2004 Vulcan® 800 (VN800-A10),
2003, 2004 Vulcan® 800 Classic (VN800-B8/L, B9)
2003, 2004 Vulcan® 1500 Classic (VN1500-E6, E7/L)

MC 04-02

ACCELERATOR PUMP DIAPHRAGM REPLACEMENT

January 16, 2004

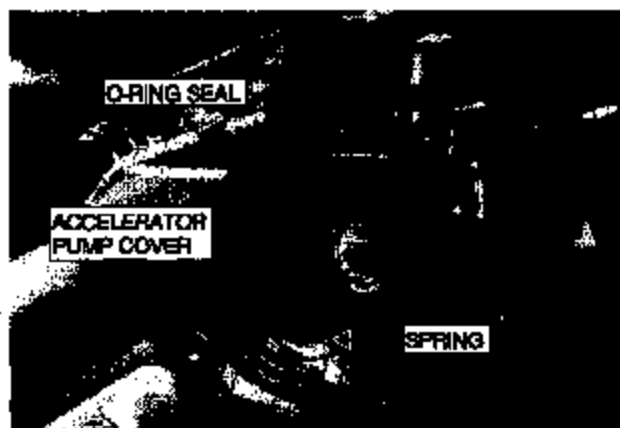
- Replace the diaphragm with new one.
- Fit the lip on the outer edge of the diaphragm into the groove on the carburetor body

- Place the O-ring seal into the carburetor body and spring into the accelerator pump cover, then install the pump cover.

Repair Verification

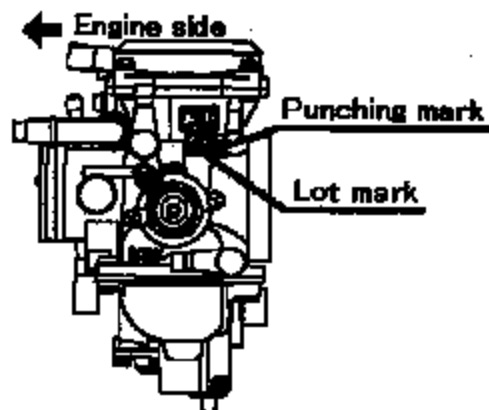
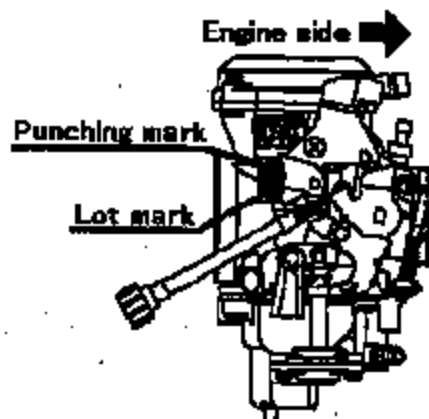
After repair, make a small punch mark in the location shown.
